**DATE:** September 18, 1970  
**TO:** Owners and Operators of Yankee Aircraft  
**SUBJECT:** Spinner/Back Plate Inspection  
**MODELS AFFECTED:** AA1-0001 thru 0216, 0218 thru 0253, 0255 thru 0263, 0265 thru 0315, 0317 thru 0334, 0336, 0338, 0339, 0341 thru 0344, 0346 thru 0349, 0351, 0353 thru 0359, 0362 thru 0366, 0368, 0373, 0375, 0376, 0380, 0382, 0383, 0385 thru 0390, 0392, 0394 thru 0406, 0411, 0413, 0415 and 0416.

SERVICE BULLETIN NO. 119

SERVICE BULLETIN NO. 119  
[Supplement No. 1]

Figure 1. Back Plate and Forward Cowl Clearance

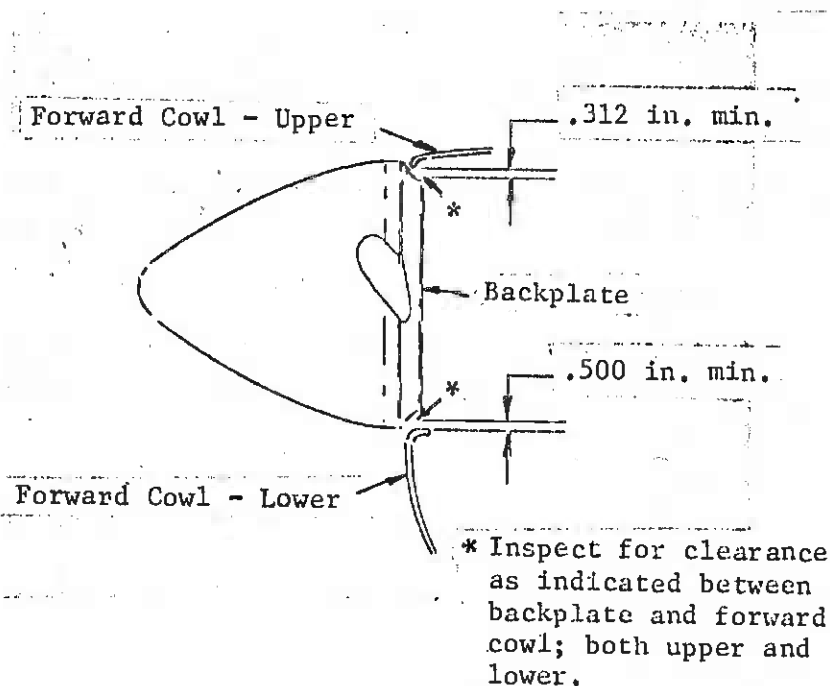
1. Inspect the static clearance between back plate and forward cowl as shown below. If clearance is insufficient, correct per instructions in Service Kit No. SK-109 (copy attached).

Figure 2. Spinner and Back Plate Inspection.

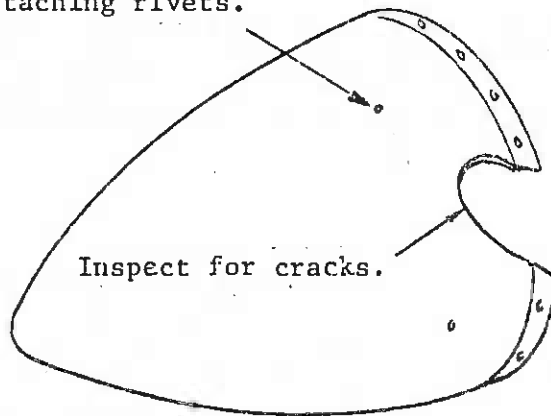
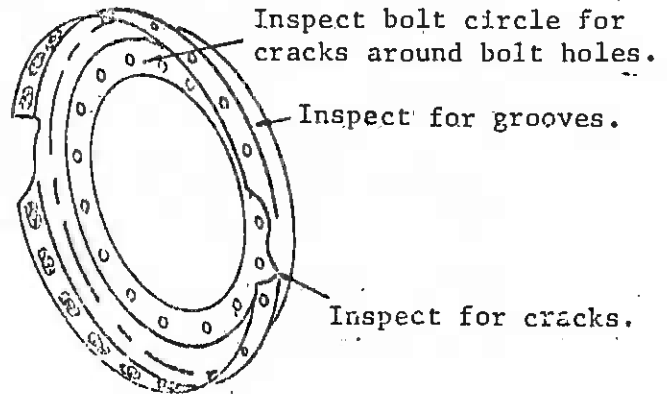
2. Remove the spinner, propeller, and spinner back plate. Inspect the spinner and back plate for cracks and deep grooves in the areas shown below.

Inspect spinner bulkhead for loose attaching rivets.

Inspect for cracks.

Inspect bolt circle for cracks around bolt holes.

Inspect for grooves.

Inspect for cracks.

4. Inspect attachment of bulkhead located in the forward end of the spinner for loose or working rivets (See figure 2 above)

3. If no cracks are found or grooves do not exceed .015 in. in depth the spinner/back plate may be reinstalled after completion of modifications as shown in Service Kit No. SK-109. If cracks are noted in either the spinner or back plate, the cracked unit must be removed from service.
